TRANS/WP.29/GRRF/2003/5
22 November 2002

PROPOSAL FOR DRAFT AMENDMENT TO REGULATION No. 13
(Braking)

Transmitted by the Expert from the United Kingdom on behalf of the ad-hoc informal group on
braking compatibility of heavy goods vehicles (HGV)

"DIAGRAM 2

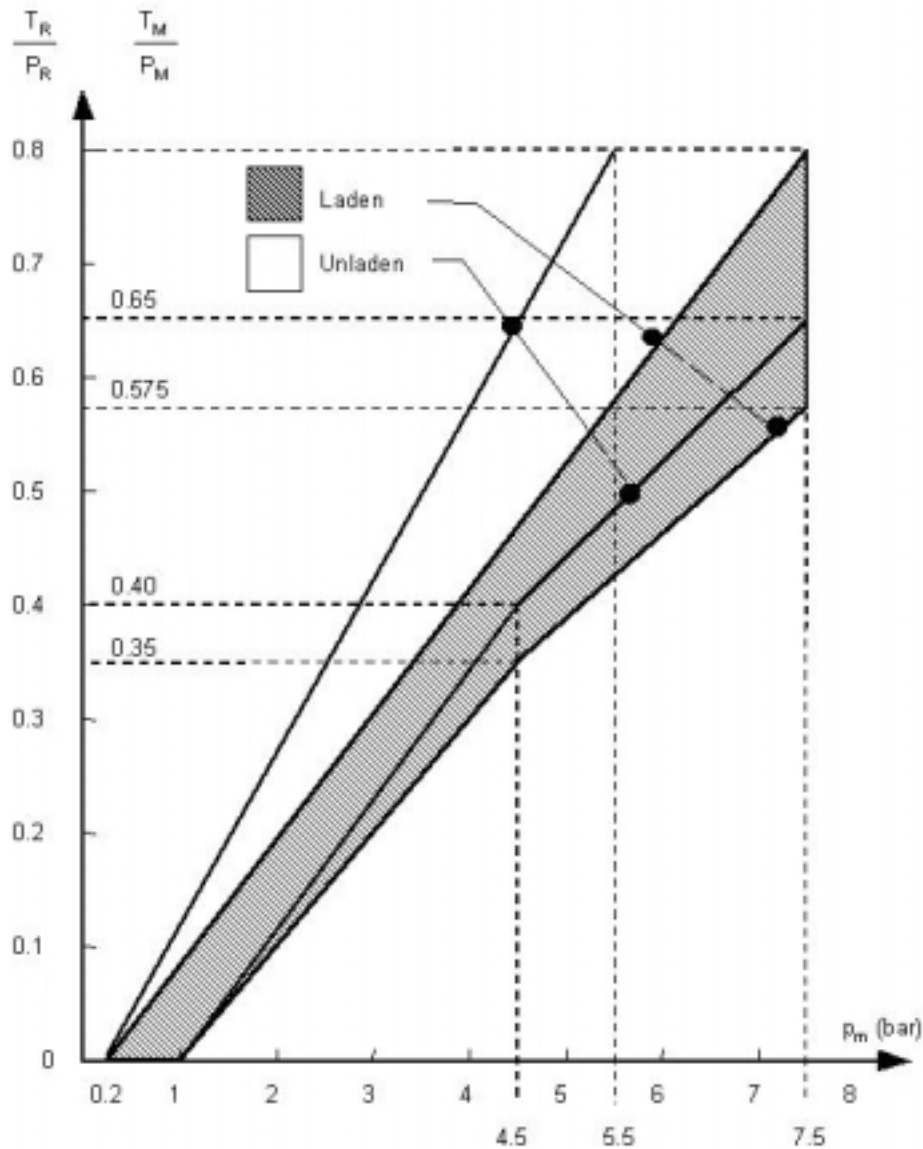
Annex 10, diagrams 2, 3 and 4A, amend to read:

Note: The relationships required by the diagram shall apply progressively for intermediate states of loading between the laden and the unladen states and shall be achieved by automatic means.

DIAGRAM 3

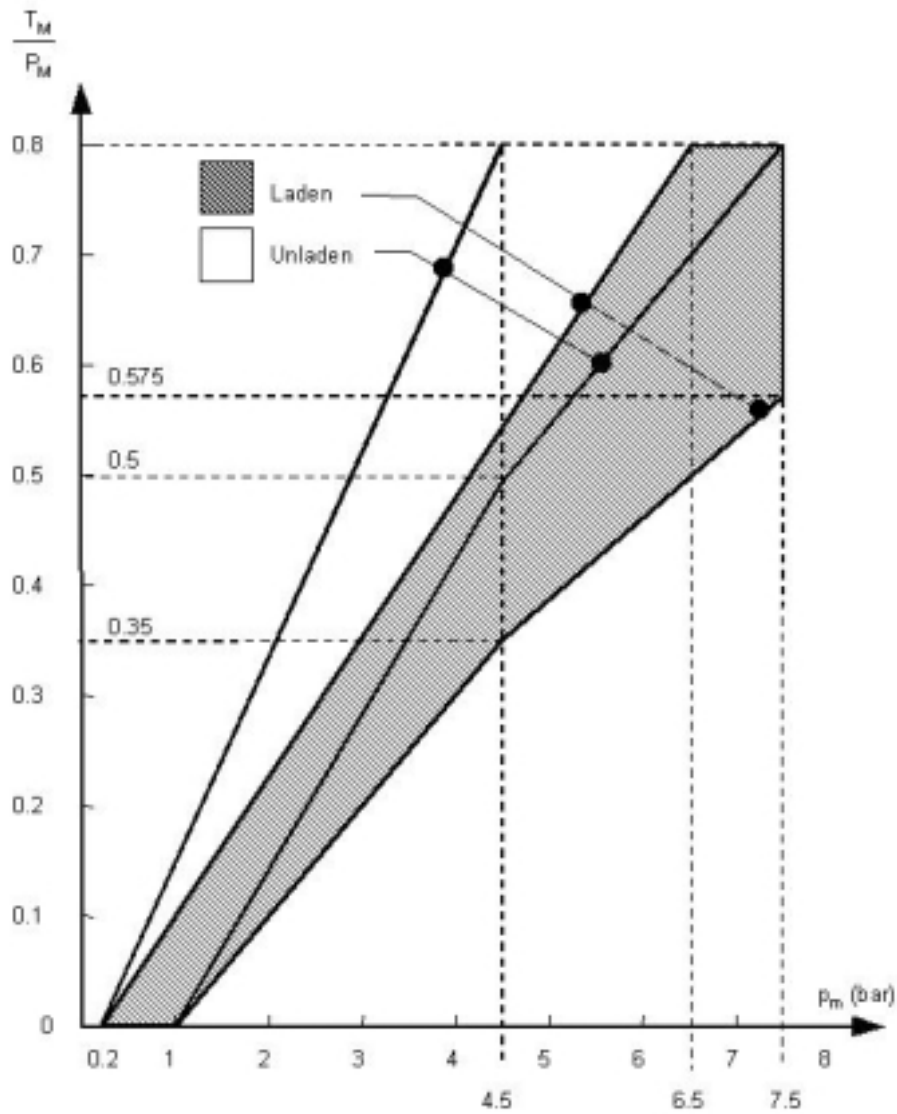
Note: The relationships required by the diagram shall apply progressively for intermediate states of loading between the laden and the unladen states and shall be achieved by automatic means.

DIAGRAM 4A
SEMI-TRAILERS
(see paragraph 4. of this annex)

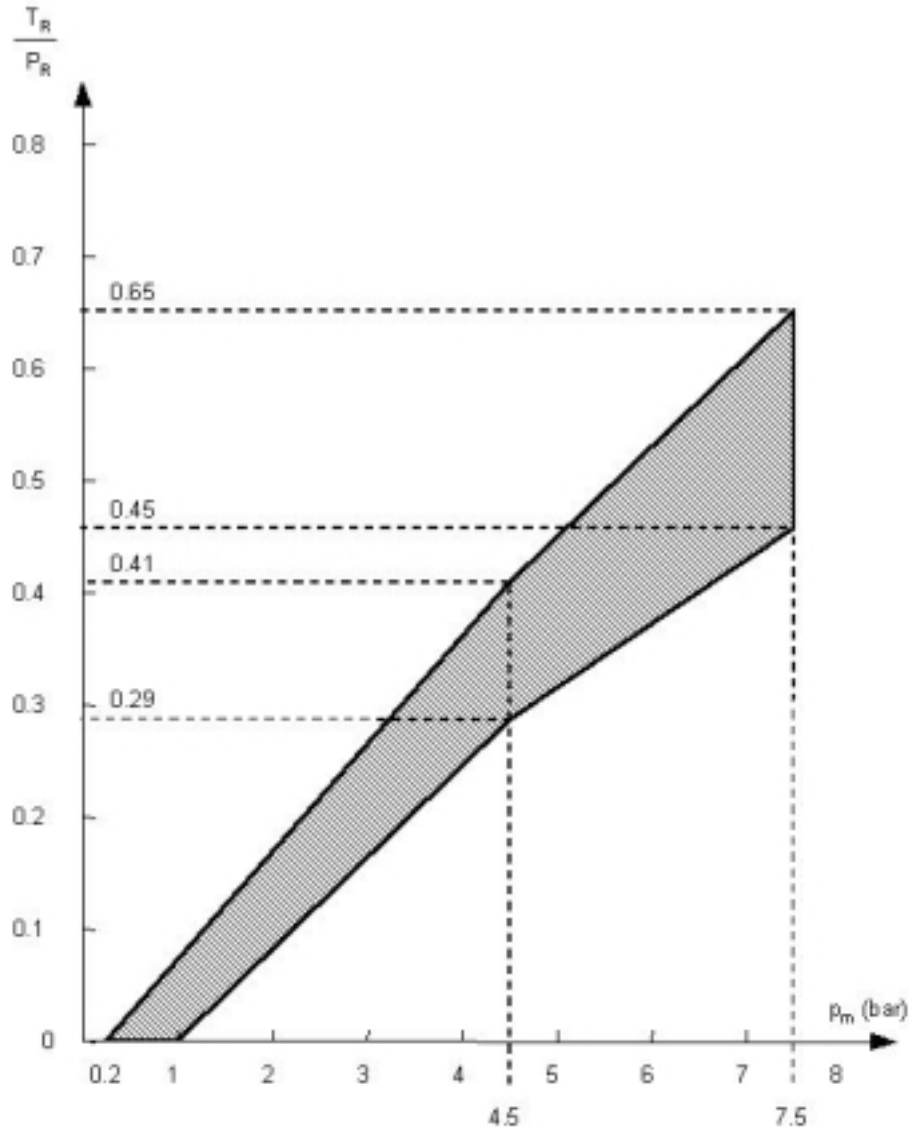
Note: The relation between the braking rate T_R/P_R and the control line pressure for the laden and unladen conditions is determined as follows:

The factors K_c (laden), K_v (unladen) are obtained by reference to diagram 4B. To determine the areas corresponding to the laden and unladen conditions, the values of the ordinates of the upper and lower limits of the hatched area in diagram 4A are multiplied by the factors K_c and K_v respectively."
